**COMMUNITY DEVELOPMENT
DEPARTMENT REPORT**

HEARING DATE: 9/19/2024
TO: Planning & Zoning Commission
FROM: Nick Napoli, Associate Planner
208-884-5533
nnapoli@meridiancity.org
APPLICANT: Sabrina Durtschi
SUBJECT: H-2024-0029
Pivot Pointe Subdivision

F. Qualified Open Space Exhibit (date: 4/10/2024)

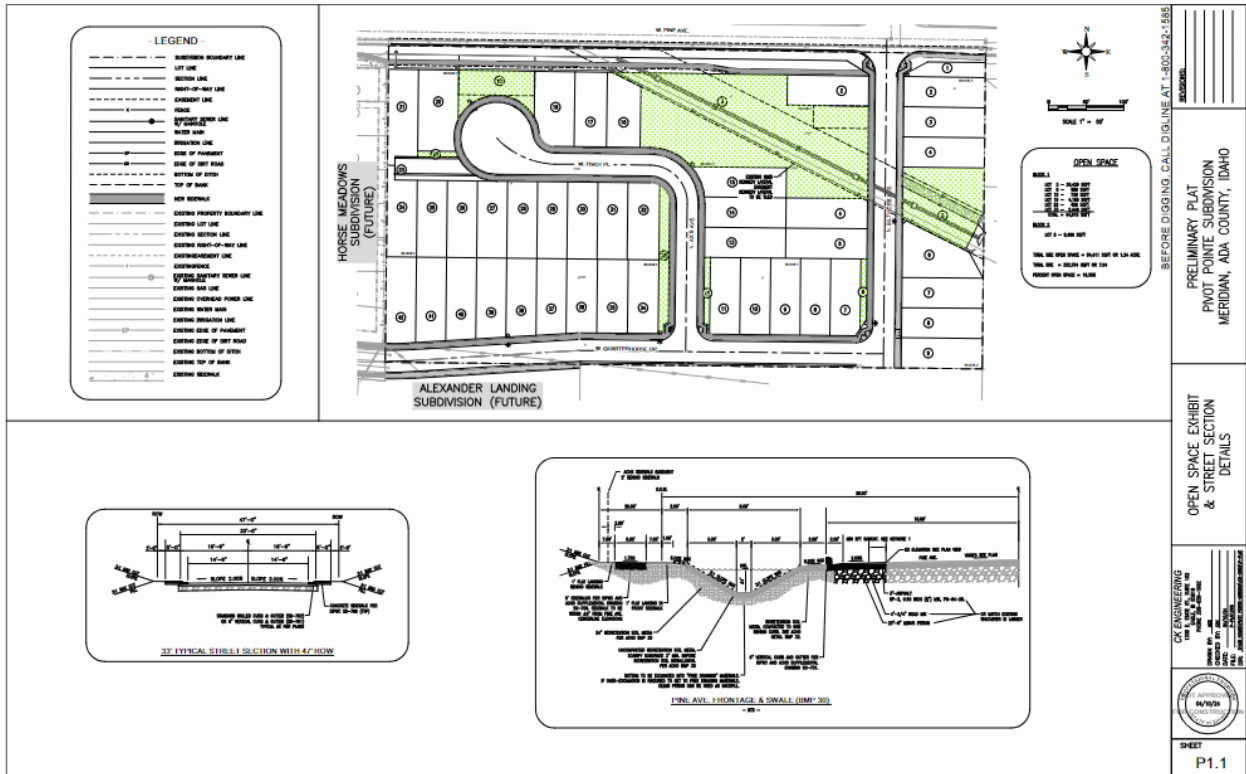
- a. **Baseline Requirement:** For developments zoned R-8 (Medium Density Residential) a minimum of 15% of the subdivisions area (7.98 acres) shall be qualified open space. *The applicant is proposing 1.15 acres of qualified open space exceeding the 1.12 acres required to meet the minimum standard. However, Staff recommends Lot 2, Block 1 is removed to create more integrated open space. The placement of Lot 2, Block 1 creates an isolated parcel that abuts open space, a gravel access road, and street landscape buffers. Additionally, the lot creates possible conflict points when having to ingress and egress for the property owner. Due to these concerns, staff finds that UDC 11-3G-3-2b "Open space shall be accessible and well connected throughout the development" is not being met.*

common area within the project. The applicant proposes a gravel access road and micro-pathway that runs through the open space for pedestrian connectivity and irrigation district access. The linear open space along the Kennedy Lateral is approximately 50 feet in width and over 500 feet in length. This linear open space connects with the Chesterfield No. 1 Subdivision's open space. This is discussed more in the amenity section below.

In order for the pathway to count towards the amenity requirements it shall be paved and landscape in accord with UDC 11-3A-8 and 11-3B-12.C to connect to N. Biltmore Avenue and W. Pine Avenue. If the irrigation district does not allow for these improvements within the easements the applicant shall provide an additional qualifying amenity equaling one point or more with the final plat application.

- b. Depict landscaping on each side of the 5-foot micro pathway running along the Kennedy Lateral.
 - c. The 5-foot pathway proposed in Lot 3, Block1 shall be paved, landscaped, and extended in accord with UDC 11-3A-8 and 11-3B-12.C to connect with N. Biltmore Avenue and W. Pine Avenue. If the irrigation district does not allow for these improvements within the easements the applicant shall provide an additional qualifying amenity equaling one point or more with the final plat application.

G. Preliminary Plat (date: 6/6/2024)

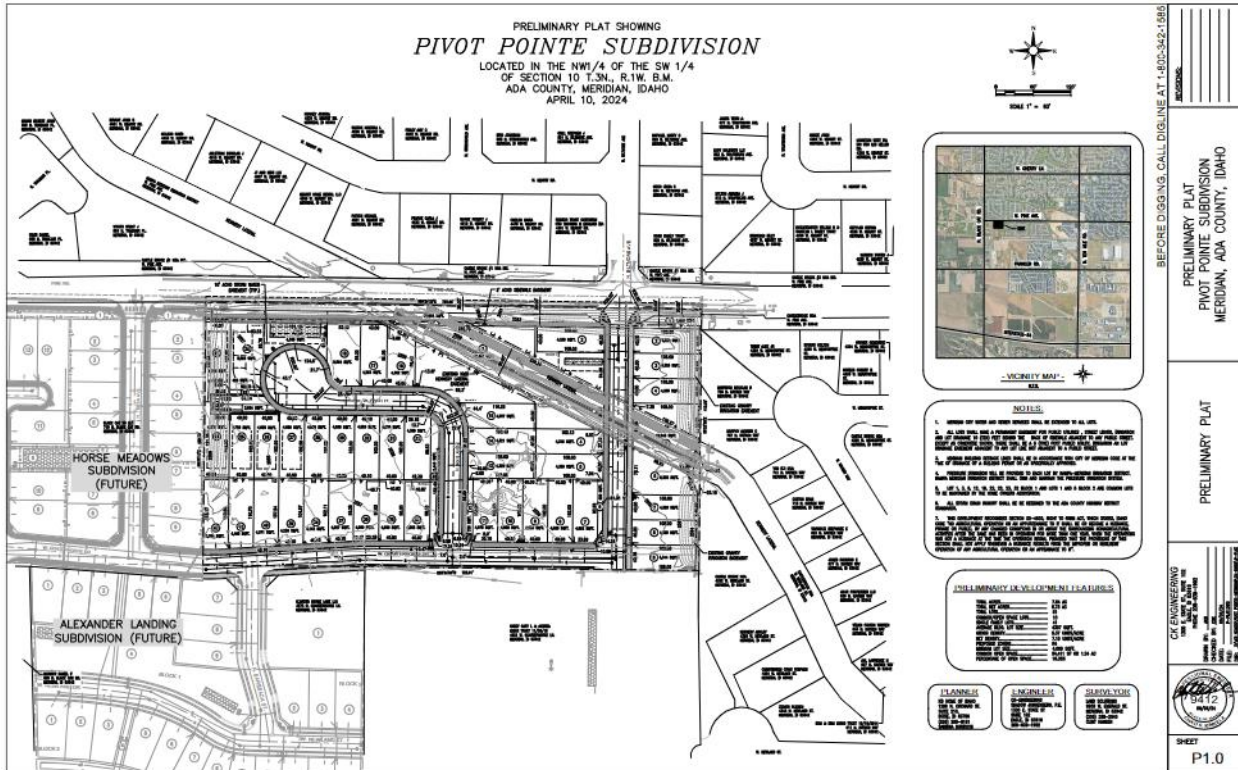
Staff is recommending the removal of [Lot 2](#), Block 1 to create more integrated open space within the development. The applicant would like the lot to remain as shown.

The subdivision features two main open space areas: a linear space along the Kennedy Lateral and another linear space on Lot 19, Block 1. The common lots 6, 12, 22, and 33 do not count as qualified open space but are provided throughout the development. The Applicant illustrates the lateral as piped underground. The large central open space area is approximately 45,935 feet in size and is the largest usable

- d. Depict a paved 5-foot micro pathway through Lot 19, Block 1.
 - e. Remove Lot 2, Block 1, and incorporate this area into the common open space for the development.
